Date Issued :	February 22, 2023	PCN Number :	513330	
Reason for Change :	Packaging Method/Quantity	/ Changing		
Description of Change :	This notification is to inform specification change. No cha		undergo changes for packaging size/ ct as part of this change.	packaging
Reason for Short Notice :	Special Request			
Assessment of Change :	No change to parts - Form/F	it/Function		
Planned Implementation Date :	May 22, 2023			
Sample Availability Date:	February 28, 2023			
Internal Molex Qualification Date :	February 28, 2023			
Last date to request Samples by Cust	omer : March 31, 2023			
<ul> <li>Before Picture</li> <li>The Minimum Line Mirror Mezz conne Before</li> </ul>	/Delivery Quantity ( ector Afte	r	ncreased for	
<ul> <li>Before Picture</li> <li>The Minimum Line Mirror Mezz conner Before MLQ/MDQ:1xSP0</li> </ul>	/Delivery Quantity ( ector Afte		ncreased for	
<ul> <li>Before Picture</li> <li>The Minimum Line Mirror Mezz conner</li> <li>Before</li> </ul>	/Delivery Quantity ( ector Afte Q MLC	r	ncreased for

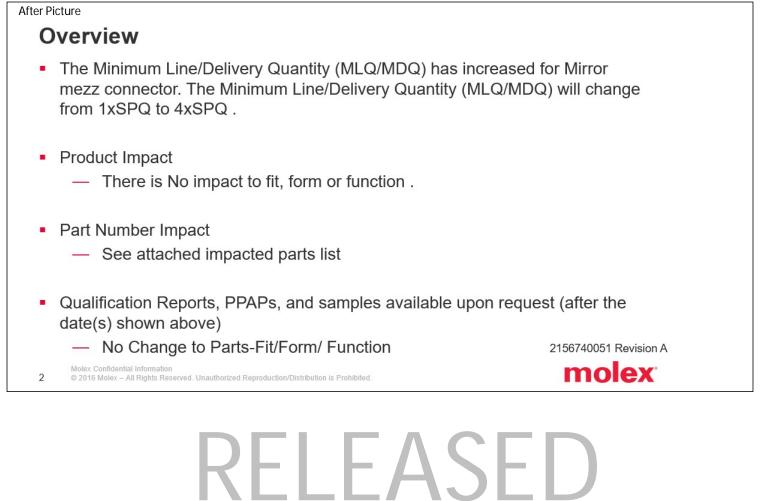
<ul> <li>Before Picture</li> <li>The Minimum Line Mirror Mezz conner Before MLQ/MDQ:1xSP0</li> </ul>	/Delivery Quantity ( ector Afte D 2 2.5mm mirro	r Q/MDQ:4xSPQ		
<ul> <li>Before Picture</li> <li>The Minimum Line Mirror Mezz conner Before MLQ/MDQ:1xSP0</li> </ul>	/Delivery Quantity ( ector Afte D 2 2.5mm mirro	r Q/MDQ:4xSPQ or Mezz Connector nirror Mezz Connecto ntation of product only		
Before Picture  The Minimum Line Mirror Mezz conne Before MLQ/MDQ:1xSPC  Product overview  Multiple State of the manufacture of	/Delivery Quantity ( ector Afte MLC 2.5mm mirro 5.5mm n Photo is used as represe	r Q/MDQ:4xSPQ or Mezz Connector nirror Mezz Connecto ntation of product only product you receive.
